ANN ARBOR HISTORIC DISTRICT COMMISSION

Staff Report

ADDRESS: 211 South Main Street, Suite A, Application Number HDC14-262

REPORT DATE: December 11, 2014

AREA OF HDC REVIEW:
 PROPOSED ROOF LEVEL PLAN, ENLARGED

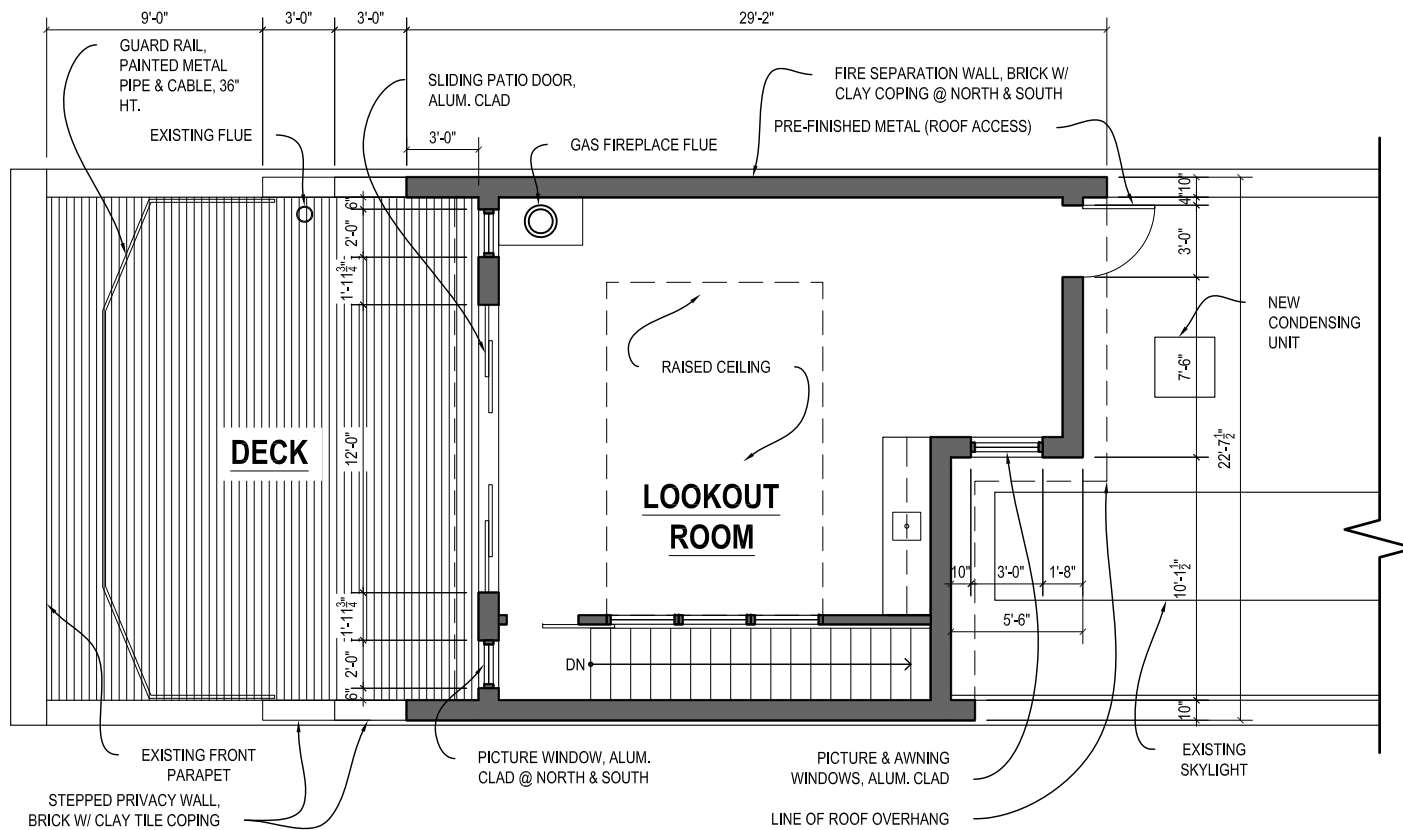
1. The proposed rooftop addition is 29 feet deep and spans the width of the 22 foot wide building. An 18' deep deck sits in front of the addition, with a metal guardrail that is inset a couple of feet from the front parapet. The sidewalls of the addition are proposed to be brick with no openings. The front and rear walls would be cementitious board and batten that is painted. The proposed windows are wood with aluminum cladding.
2. Per line-of-sight drawings provided, only a metal chimney will be visible to a person standing across South Main Street. The parapet on the building next door to the south is slightly lower, so it is possible that a small part of the brick sidewall may be seen from the sidewalk across the street to the south. Since the building is mid-block, the work should

4. Per the SOI *Guidelines* for additions, no character-defining features of the historic building are obscured, damaged, or destroyed by this proposal. The addition's height is low, and is set back from the parapet 18' and stepped in order to minimize the line of sight from pedestrians on Main Street. The materials and methods of construction clearly delineate what is historic and what is new. The design is contemporary.

Subject: EXISTING CONDITIONS: 6 WINDOWS ON WEST FACADE

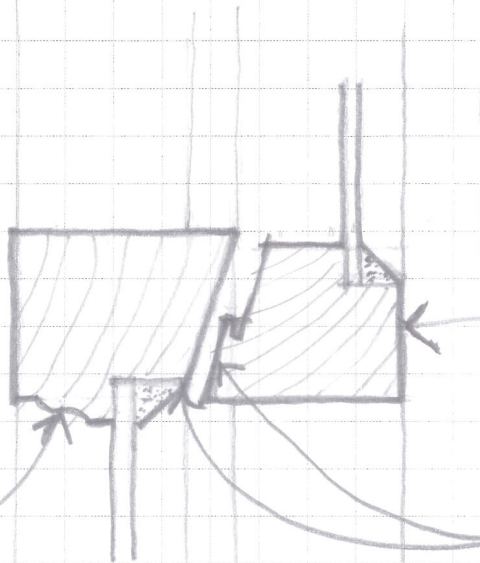
5. The lower sashes of the front (west) windows are stated to be replacements in the application. The Review Committee will confirm this at the site. Replacement of non-original lower sashes with new custom built ones that match the dimensions of the historic upper sashes is appropriate. The use of insulated glass on both the lower and upper sashes is appropriate as long as the glass is clear and the inset from the face of the wooden sash to the face of the glass does not change.
